MEMORANDUM

TITLE: PUBLIC HEARING: Subdivision Permit and Plat for The Life, Laramie County, WY.

PZ-25-00064

THE LIFE
SUBDIVISION

THE LIFE

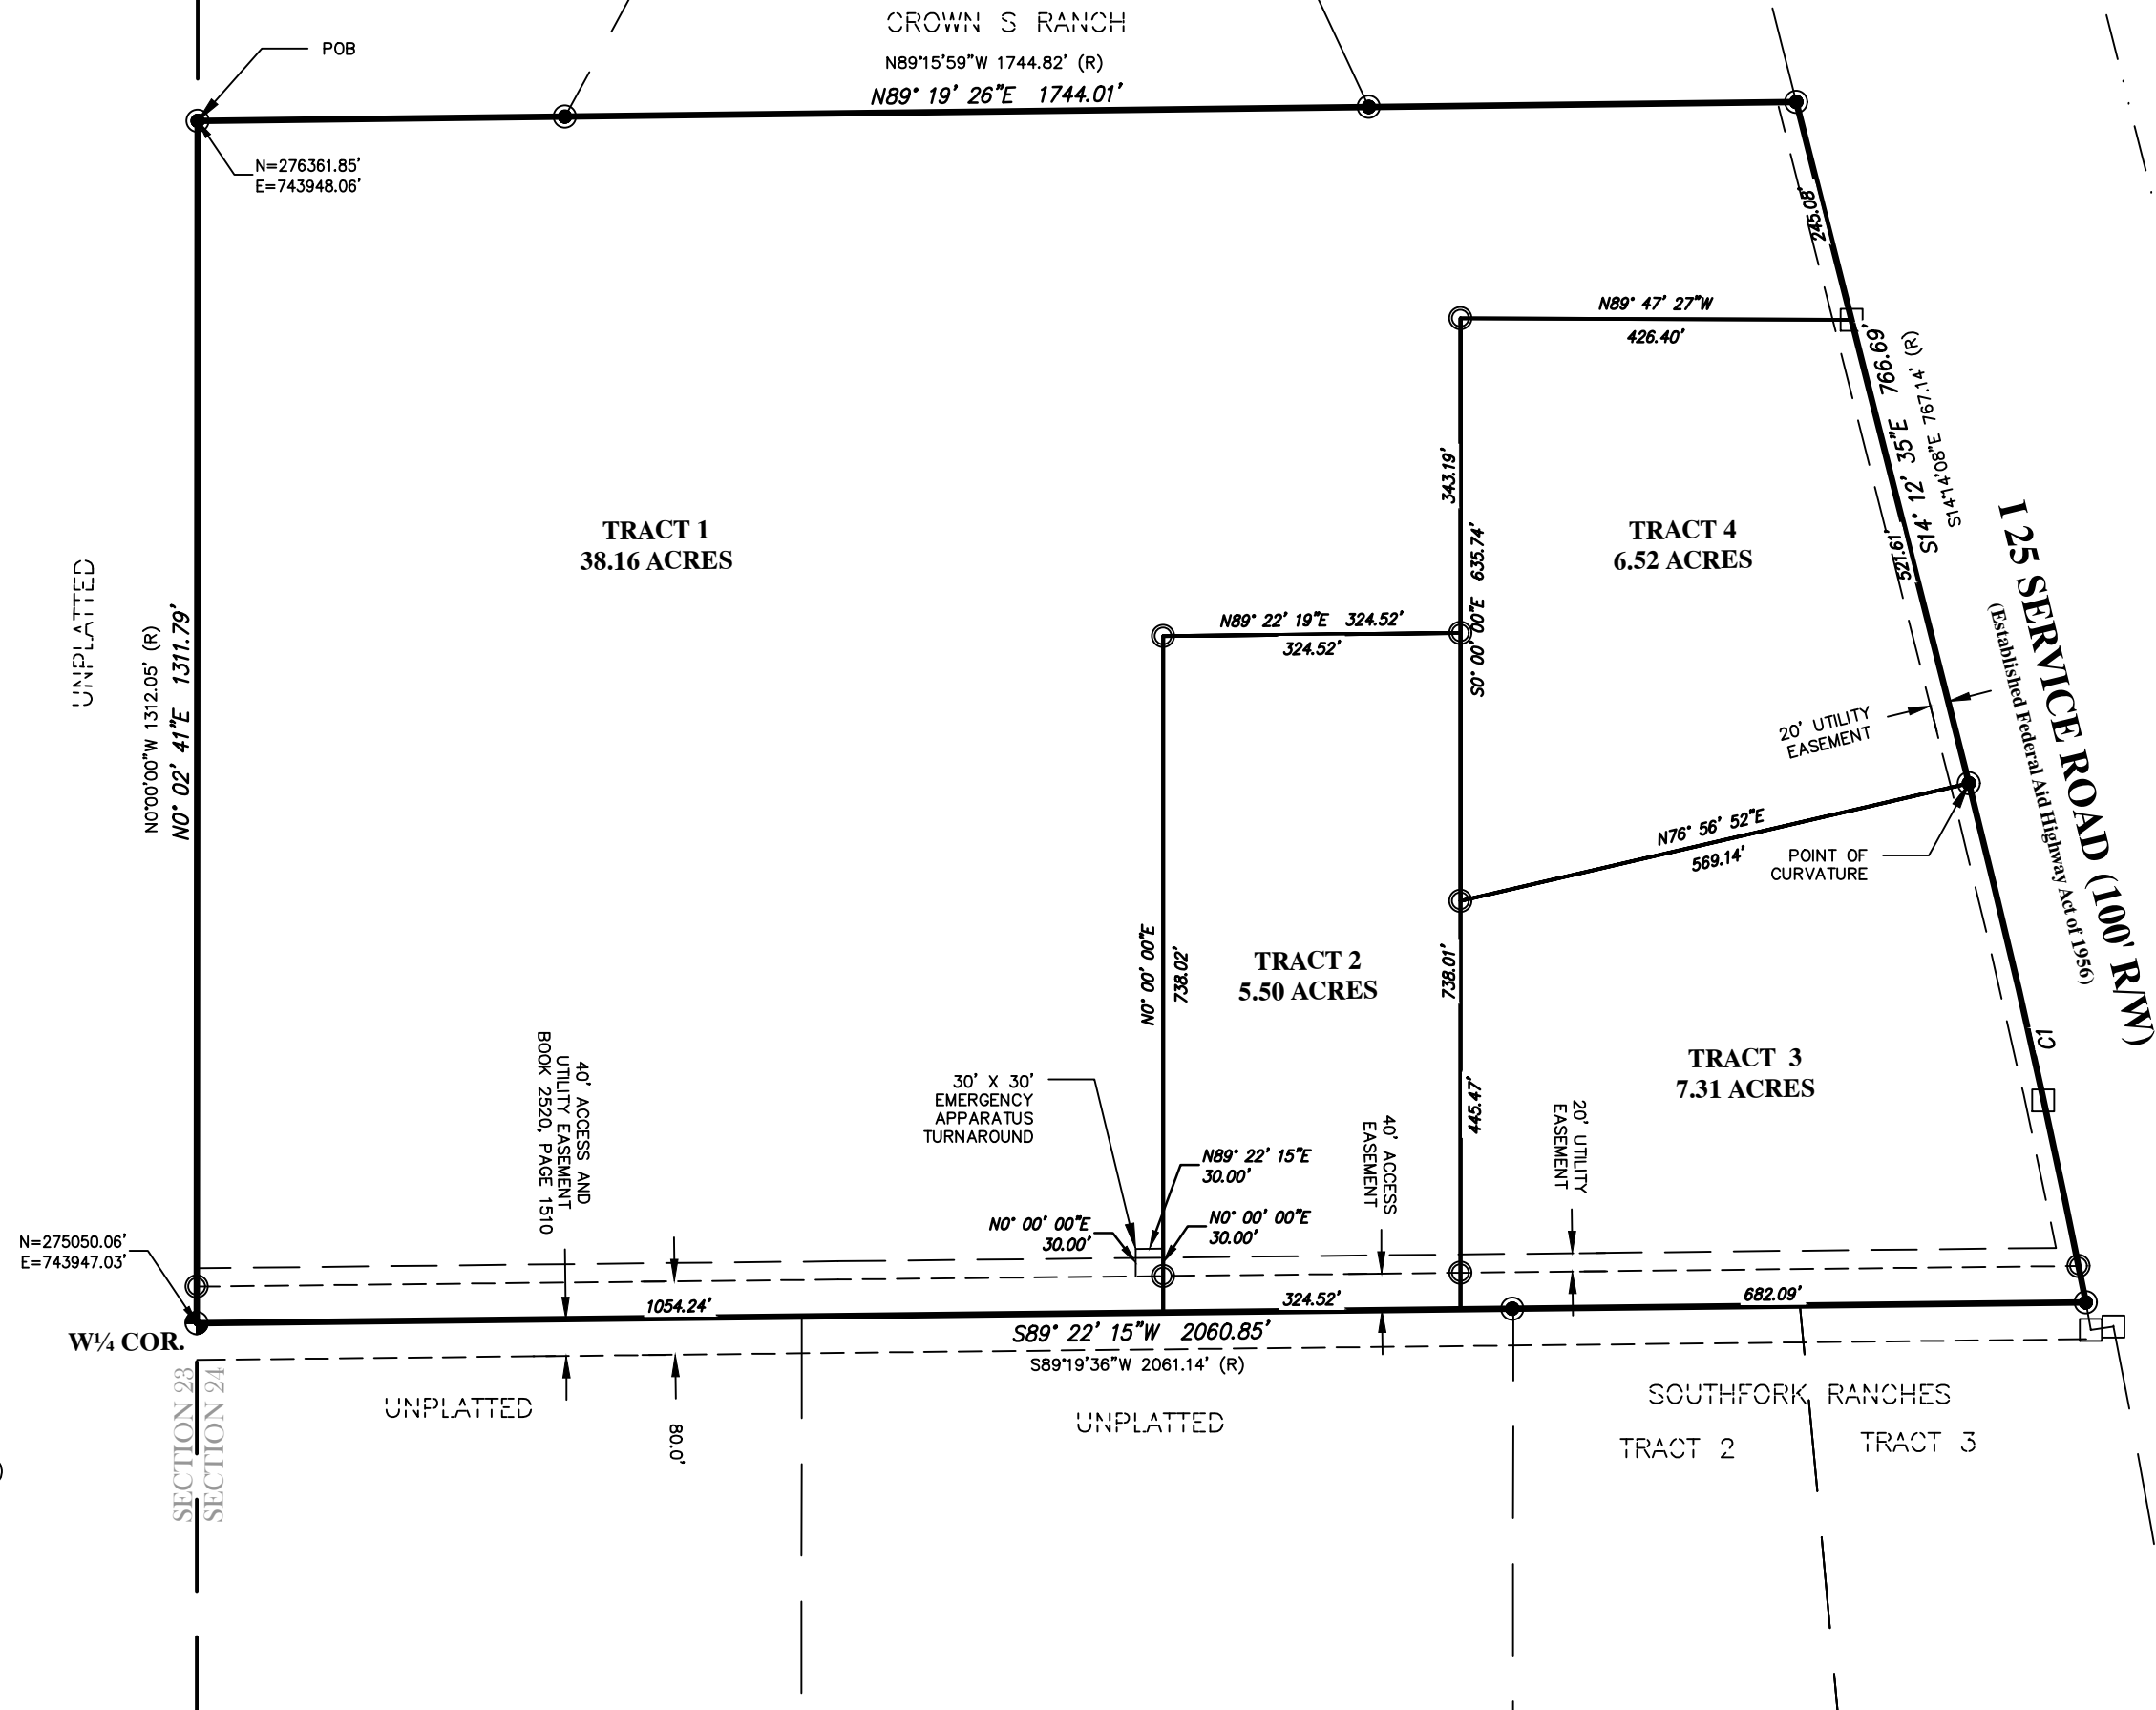
6.Per 4-5-102.c. the plat drawing shall include the following items: 14.) Plats that show adjacent or internal existing roadways and rights of way shall indicate on the plat how the roadway was established (i.e., dedicated to the public via plat, petition, declared, etc.). How was the I-25 Service Road established? 21.) A legend that defines all the various symbols, line types, shading/hatching, etc. used in the drawing. The legend shown on the plat only defines symbols, but not line types.

7.The Tract numbers for Tracts 2 and 3 of the Southfork Ranches should be labeled on the plat drawing.

1.Per 4-5-102.c. the plat drawing shall include the following items: 4.) Dedication and acknowledgment statements must be executed by all owners of legal and equitable interests in the property being subdivided/developed. The acknowledgement shall be located near the dedication on the plat. The dedication of right of ways and easements is mentioned in the DEDICATION, however it does not define if

they are dedicated to the public or for any other purpose. 10.) For subdivisions in the County, survey tie(s) by bearing/azimuth and the distance to the nearest public land survey system monument shall be accurately described on the plat. In addition, for the purposes of enhancing the City and County GIS Program framework, all public land survey corners on or within the subdivision boundary shall have field observation coordinates provided on the plat. These coordinates shall reference Wyoming State Plane Coordinate System, East Zone, U.S. Survey foot, NAD 1983(CORS96). The coordinates shall be observed and verified at the time of the plat survey. There are no Wyoming State Plane field observation coordinates shown on the plat. 16.) Where applicable, curve data showing the radius, central angle, arc length, chord bearing/azimuth and distance and any notation of non-tangent curves. The location of points of curvatures and intersections shall be shown. The point of curvature for the curve on the east boundary of the subdivision should be shown. 18.) The right-of-way lines, widths and names of all streets, roads, and easements within and adjacent to the proposed subdivision/development. What is the width of the I-25 SERVICE ROAD portion of I-25?

4.Per 4-5-102.c. the plat drawing shall include the following items: 14.) Plats that show adjacent or internal existing roadways and rights of way shall indicate on the plat how the roadway was established (i.e., dedicated to the public via plat, petition, declared, etc.). How was the I-25 Service Road established?

6.Per 4-5-102.c. the plat drawing shall include the following items: 14.) Plats that show adjacent or internal existing roadways and rights of way shall indicate on the plat how the roadway was established (i.e., dedicated to the public via plat, petition, declared, etc.). How was the I-25 Service Road established? 21.) A legend that defines all the various symbols, line types, shading/hatching, etc. used in the drawing. The legend shown on the plat only defines symbols, but not line types.

7.The Tract numbers for Tracts 2 and 3 of the Southfork Ranches should be labeled on the plat drawing.

1. ack 2. ack 3. ack 4. ack 5. the note will remain as is. We have wydot approval per taylor mccort.
